**LEBANON PLANNING BOARD
DECEMBER 17, 2024 - 7:00 PM
COUNCIL CHAMBERS, CITY HALL OR
REMOTE VIA VIRTUAL PLATFORM
LEBANONNH.GOV/LIVE**

Re: The Brickyard Multi-family Planned Unit Residential Development (PURD)
174 Hanover Street Ext. & 238 Hanover Street (Map 48 Lots 1, 2, & 4 and Map 63 Lot 1)
Project Description and Impact Statement for Site Plan Review

Re: Proposed Multi-Family Development ("The Brickyard").
Site Plan Review Application
PUD/PURD Narrative Pieces

Open Space Plan

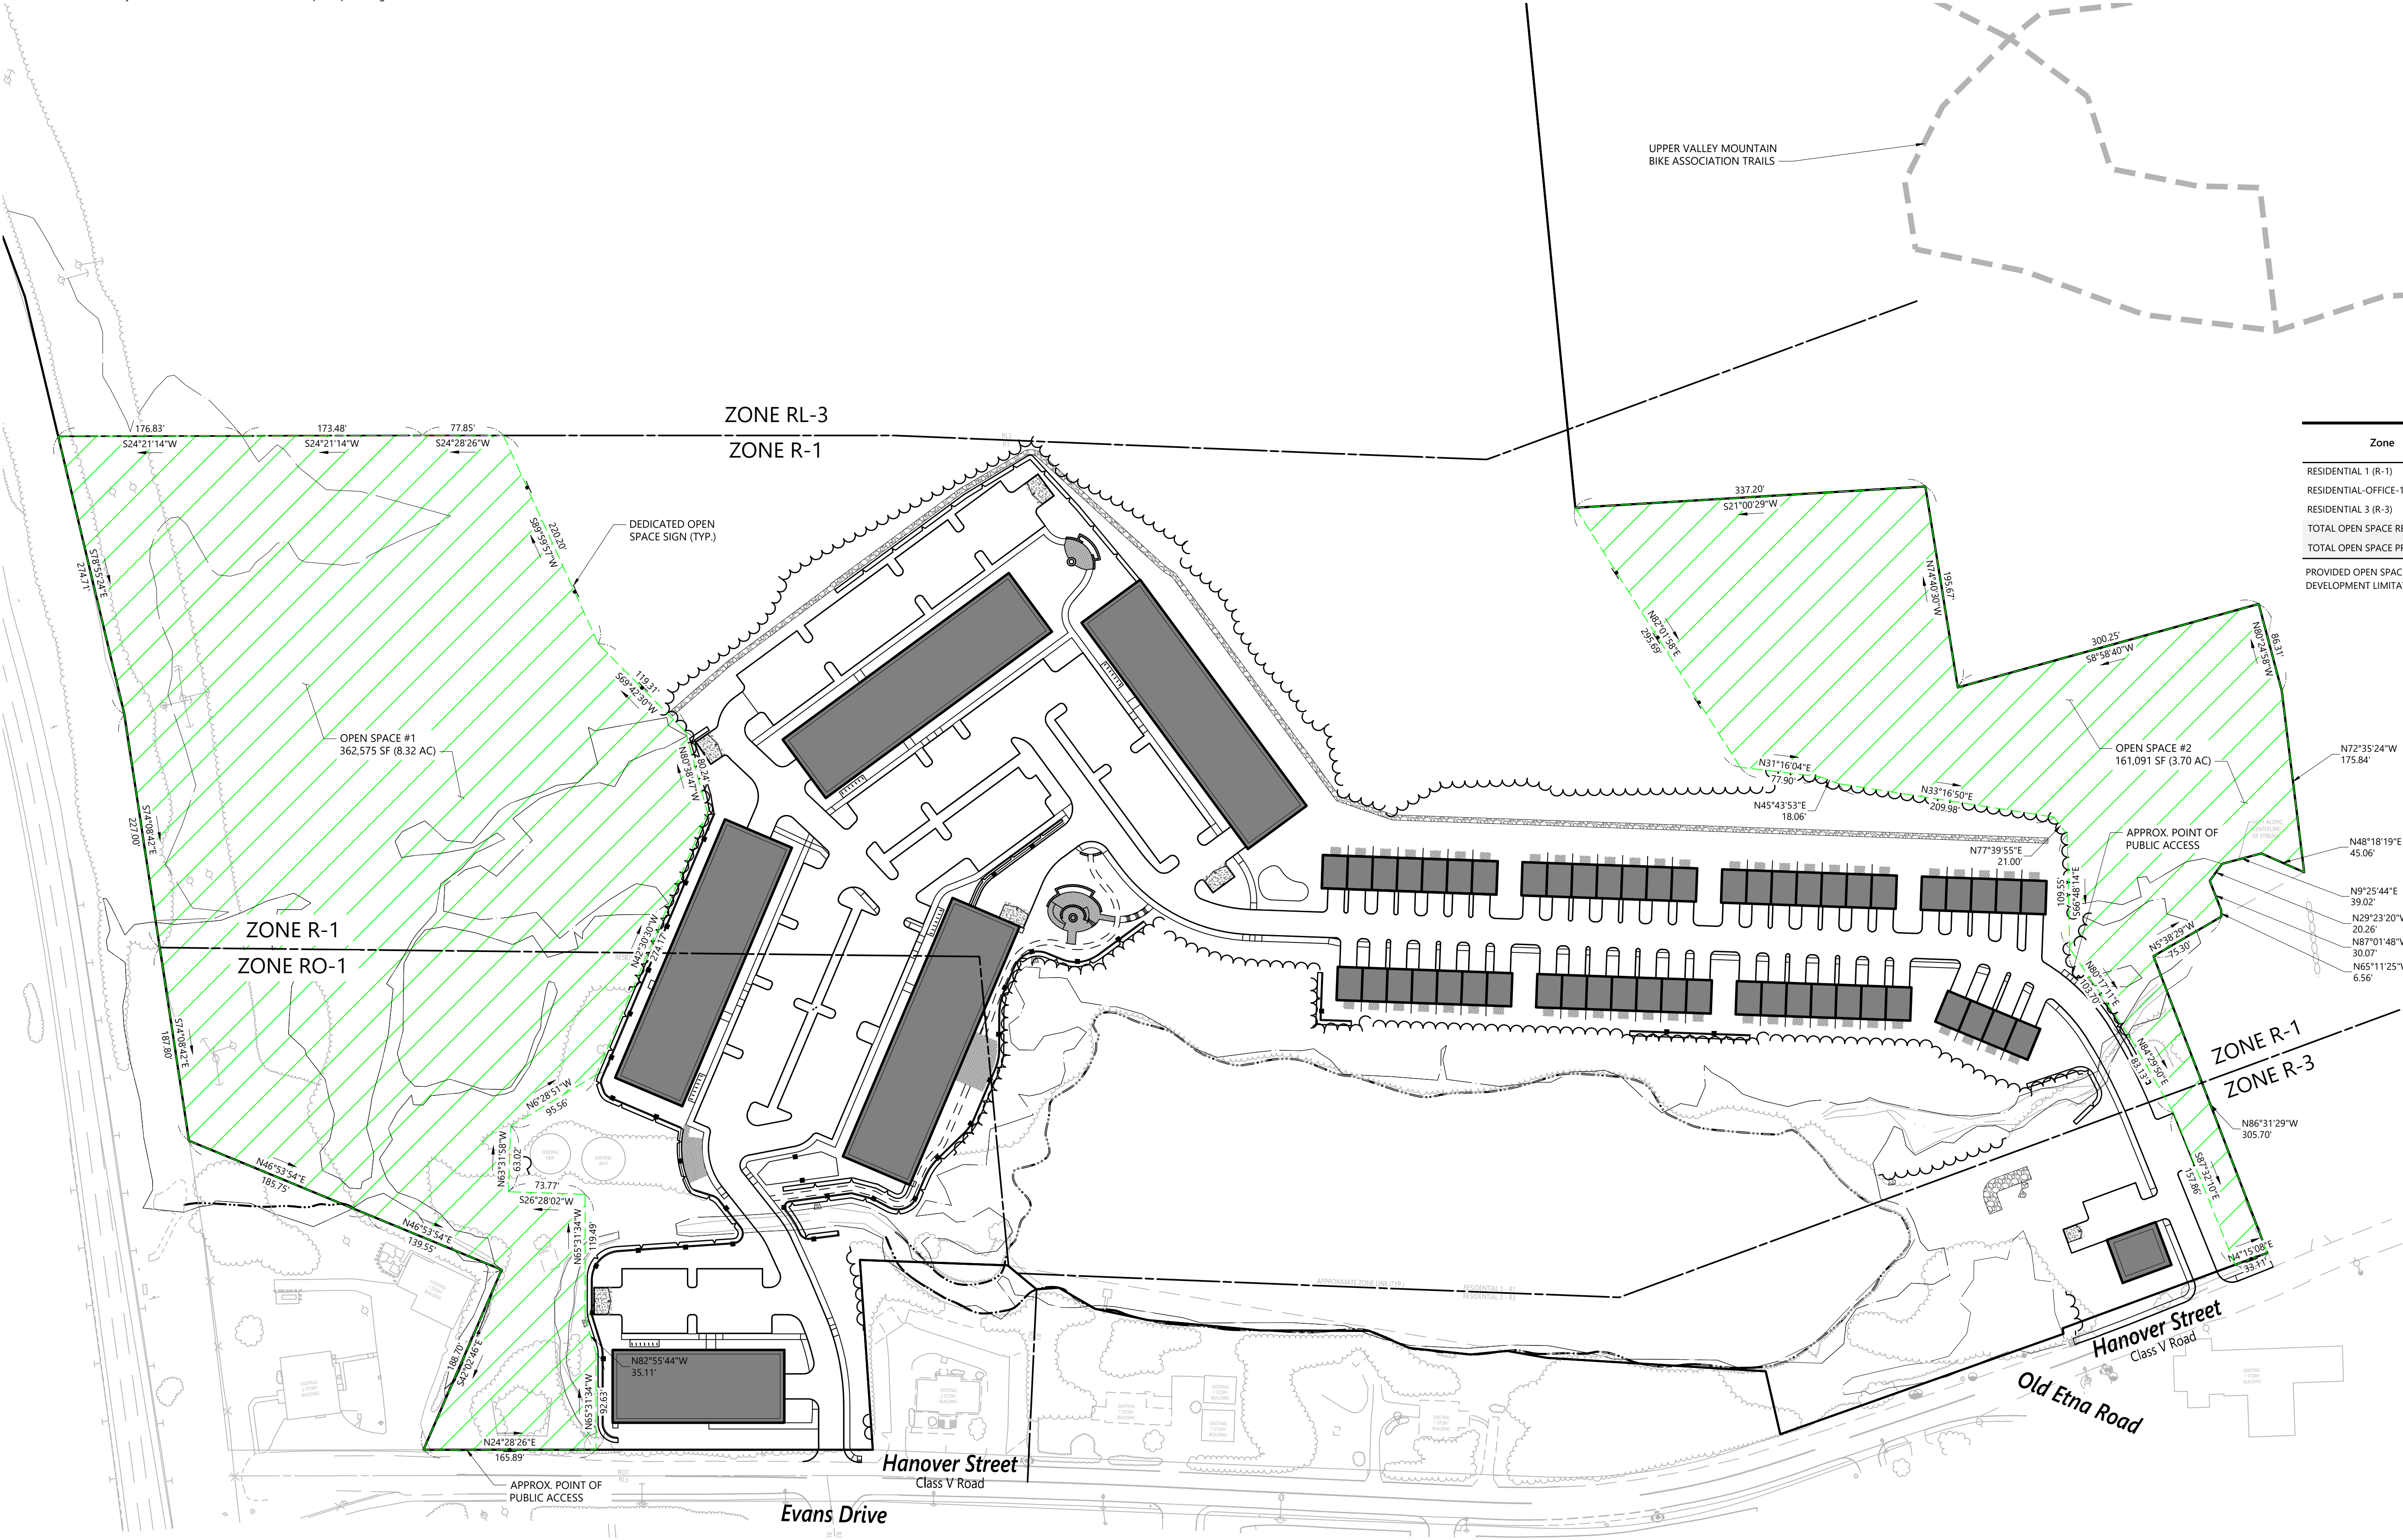
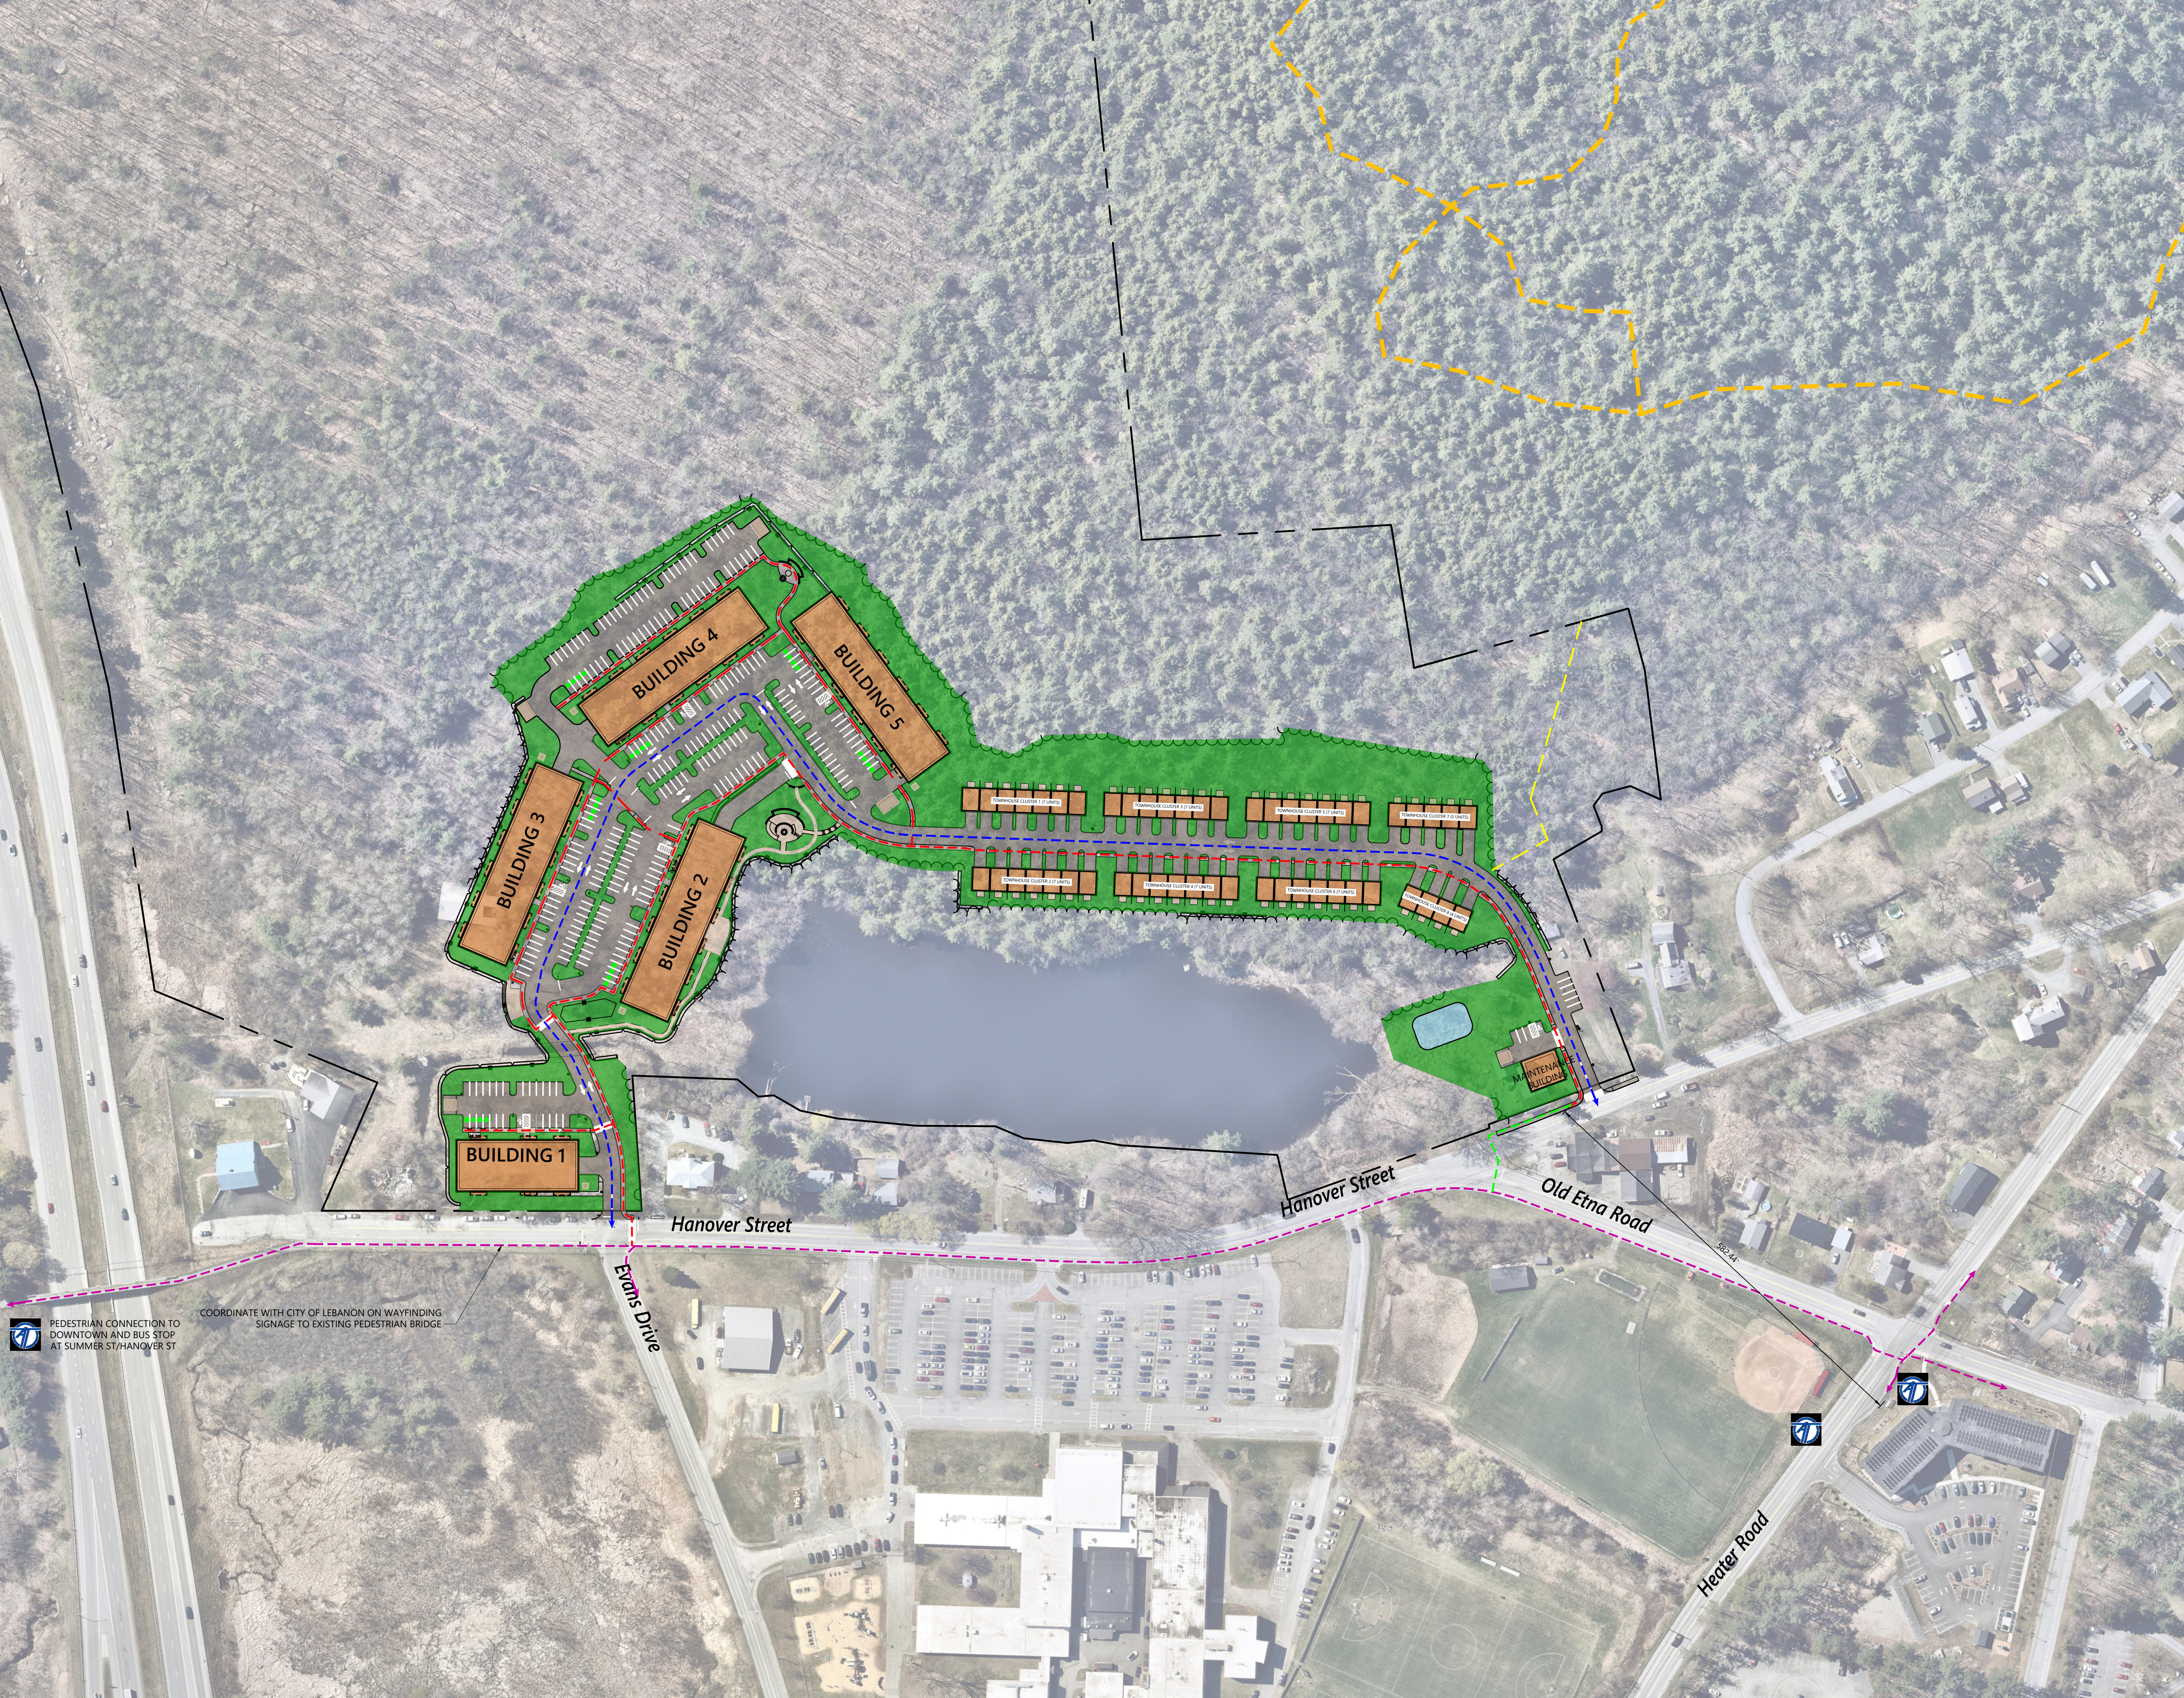
Regarding the Open Space Plan (sheet C1.2, page 3 of the 53-page plan with a latest issue date of 12/4/24), staff has the following comments:

PROVIDED OPEN SPACE SHOULD MATCH OR SLIGHTLY EXCEED REQUIRED SO THAT IT IS NOT A FUTURE DEVELOPMENT LIMITATION.

Response: The PUD/PURD narrative has been updated to reference that the Open Space Plan (C1.2) has been revised to include metes and bounds to define the area, as well as physical signage being added to the plans.

Response: The Open Space Plan has been updated. Refer to Sheet C1.2.

Response The Open Space Plan has been updated. Refer to Sheet C1.2.

Response: The Open Space Plan has been updated. Refer to Sheet C1.2.

Response: The Open Space Plan has been updated. Refer to Sheet C1.2.

Response: The Open Space Plan has been updated. Refer to Sheet C1.2.

Response: The Open Space Plan has been updated. Refer to Sheet C1.2.

Response: The Open Space Plan has been updated. Refer to Sheet C1.2.

Response: The Open Space Plan has been updated. Refer to Sheet C1.2.

Not Approved for Construction
Drawing Title
Access and Circulation Plan

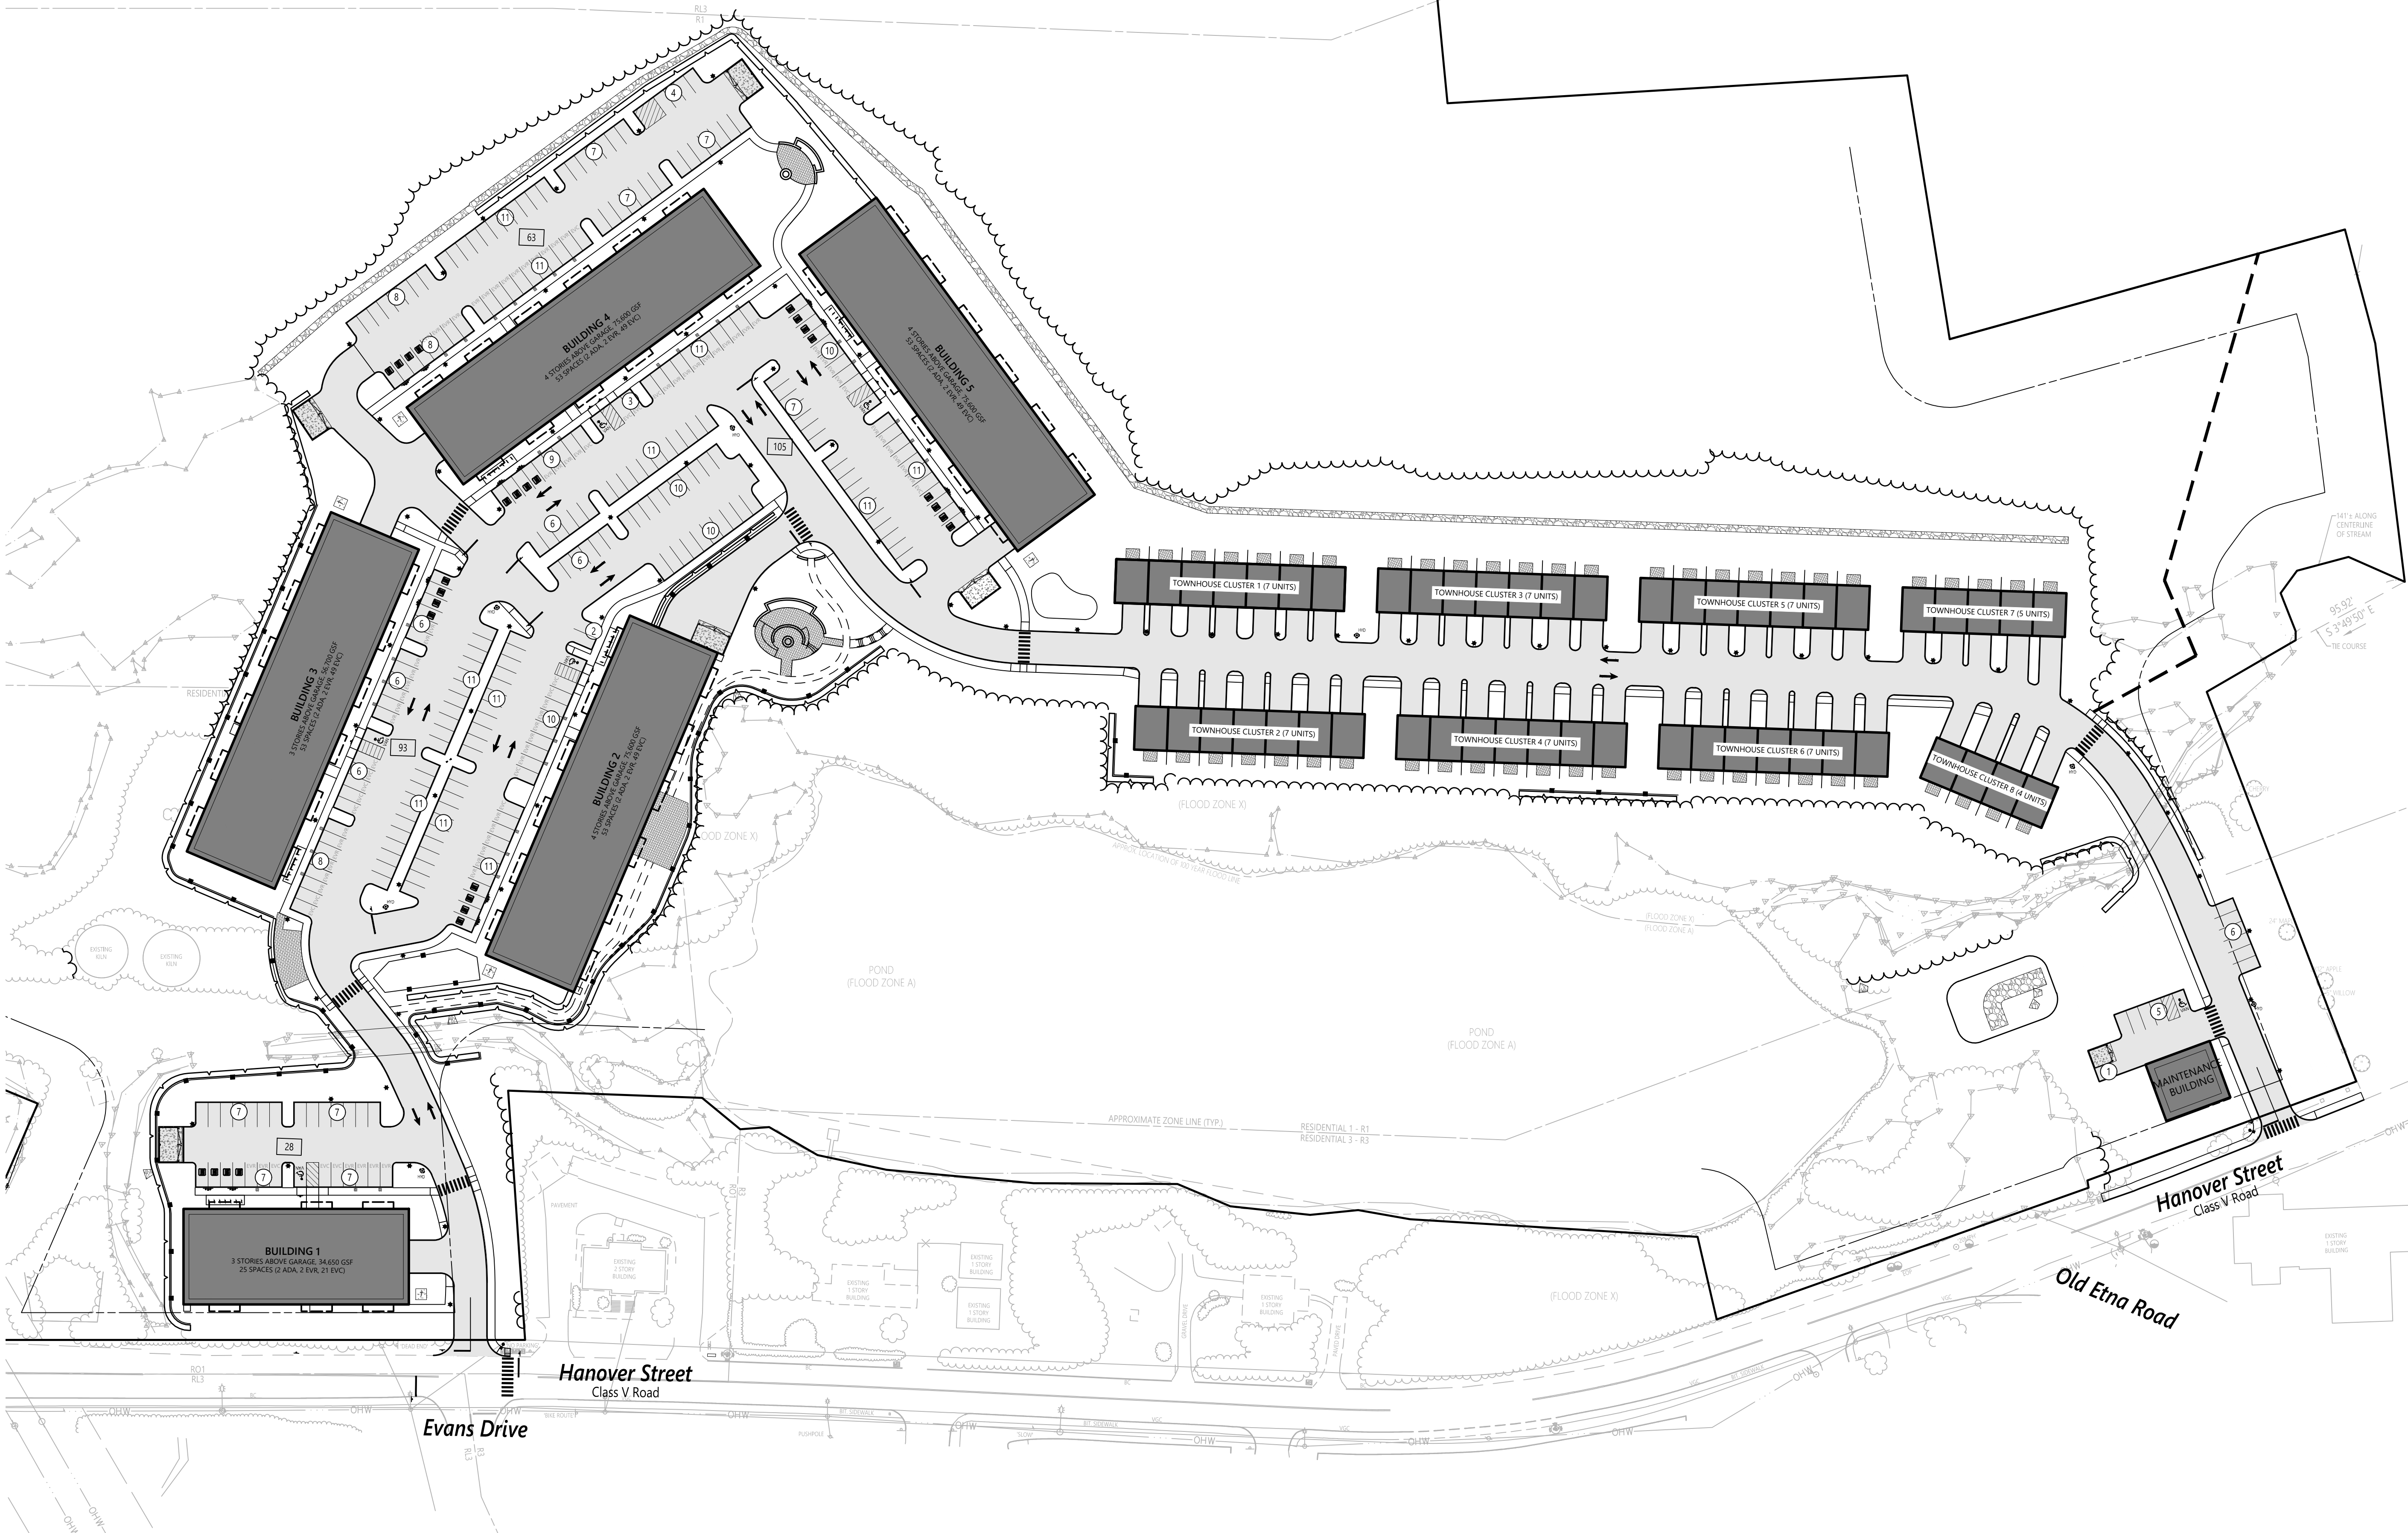
Comment 25. *Sheet 4 (C1.3)*
